PIC16C64A Rev. A Silicon Errata Sheet

The PIC16C64A (Rev. A) parts you have received conform functionally to the Device Data Sheet (DS30234D), except for the anomalies described below.

In the Device Data Sheet (DS30234D), the following clarifications and corrections should be noted.

FIGURE 1: SCK PULSE VARIATION USING TIMER2/2

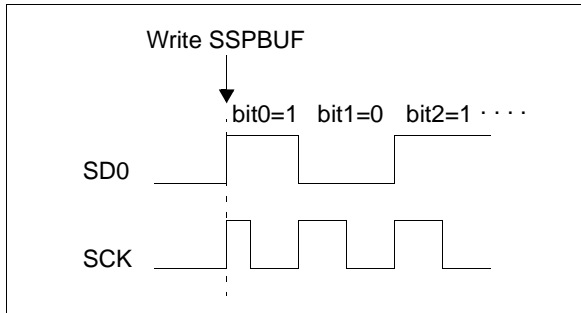
When the SPI is using Timer2/2 as the clock source, a shorter than expected SCK pulse may occur on the first bit of the transmitted/received data (Figure 1).

To avoid producing the short pulse, turn off Timer2 and clear the TMR2 register, load the SSPBUF with the data to transmit, and then turn Timer2 back on. Refer to Example 1 for sample code.

FIGURE 1: WRITES TO TIMER1 (EXTERNAL CLOCK/OSCILLATOR MODE)

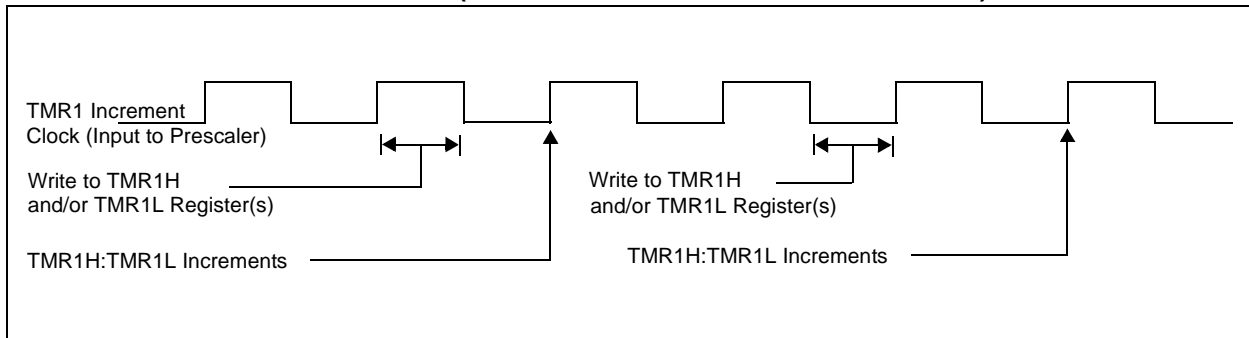
The operation of Timer1 needs some clarification when the timer registers are written and the TMR1ON bit is set.

The internal clock signal, that is the input to the TMR1 prescaler, affects the incrementing of Timer1 (TMR1H:TMR1L registers and the Timer1 prescaler). When the Timer1 registers are NOT written, the Timer1 will increment on the rising edge of the TMR1 increment clock.

When the TMR1H and/or TMR1L registers are written while this clock is high, TMR1 will increment on the next rising edge of this clock.

When the TMR1H and/or TMR1L registers are written while this clock is low, TMR1 will not increment on the next rising edge of this clock, but must first have a falling clock and the rising clock for TMR1 to increment.

Figure 1 shows the two cases of writes to the TMR1H and/or TMR1L registers. Due to the V_{IH} and V_{IL} thresholds on the oscillator/clock pins, external Timer1 oscillator components, and external clock frequency, the Timer1 increment clock may not be of a 50% duty cycle.

The TMR1 increment clock is out of phase of the T1OSO/T1CKI pin by a small propagation delay.
